# REGULAR PLANNING COMMISSION AGENDA

**PLANNING COMMISSION STAFF**  
**MAJOR SUBDIVISION SMP2024 0002**  
**HEARING DATE: MAY 14, 2024**

**DATE:** May 20, 2024  
**TO:** Mandy Cole, Chair, Planning Commission  
**BY:** David Matthew Peterson, Planner II *David Peterson*  
**THROUGH:** Jill Lawhorne, Director, AICP

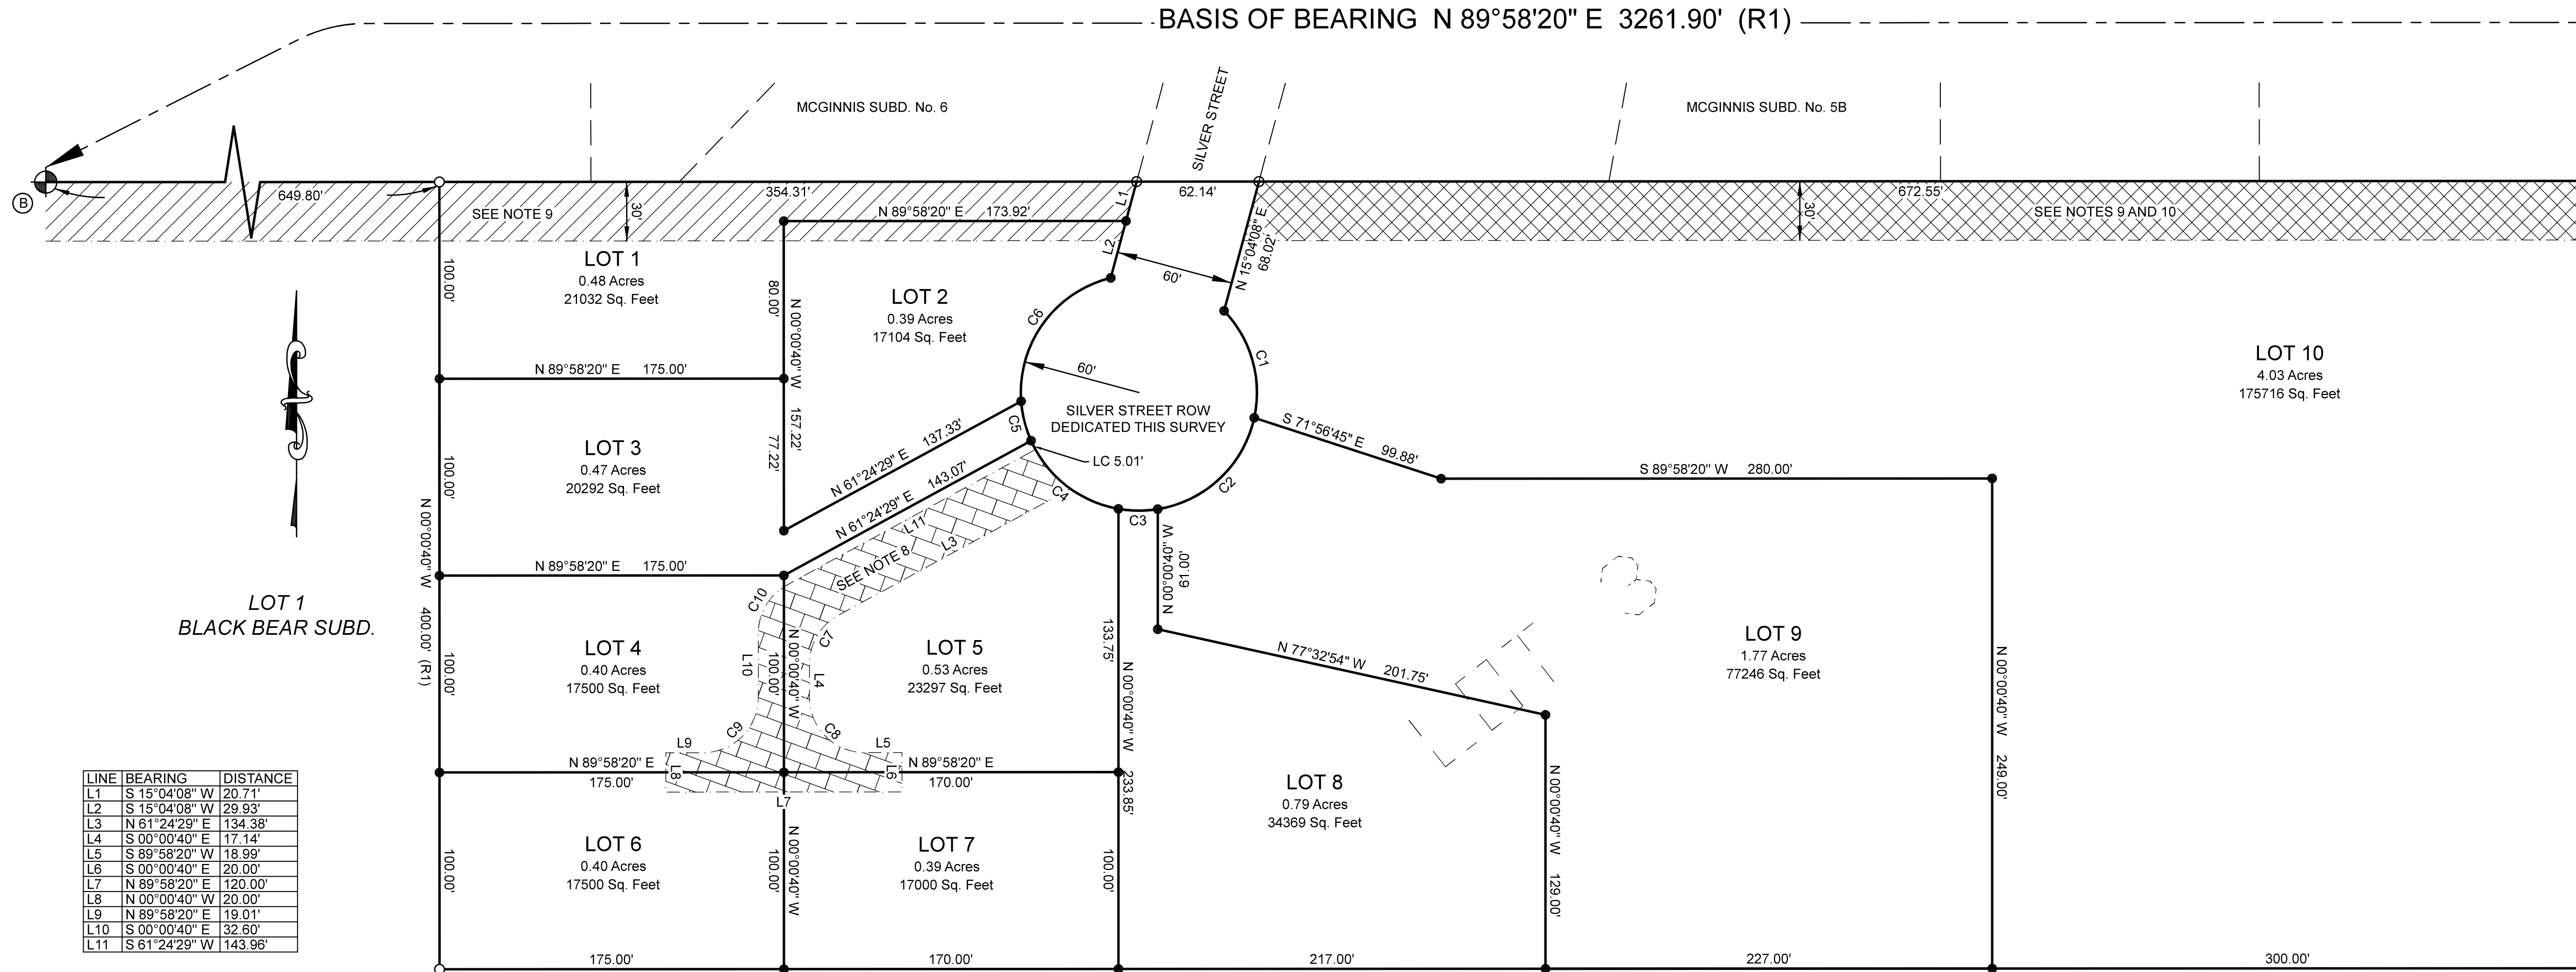
1. Label adjacent McGinnis Subdivision lots.
2. In the basis of bearing note, add “n” to “show”.

1. Include Private Shared Access dimension or note attesting to the PSA being 30 feet in width.
2. Update/Revise Closure Report bearings or provide clarification regarding discrepancies.
3. Revise Case Number to be: SMP2024-0002
4. Please include a fine dashed line to call out property setbacks. Reason being, Title 49 calls out that wherever two zones abut one another, the greater of the two setbacks will be applied to both lots.
5. Show CBJ trail in the drainage easement area.
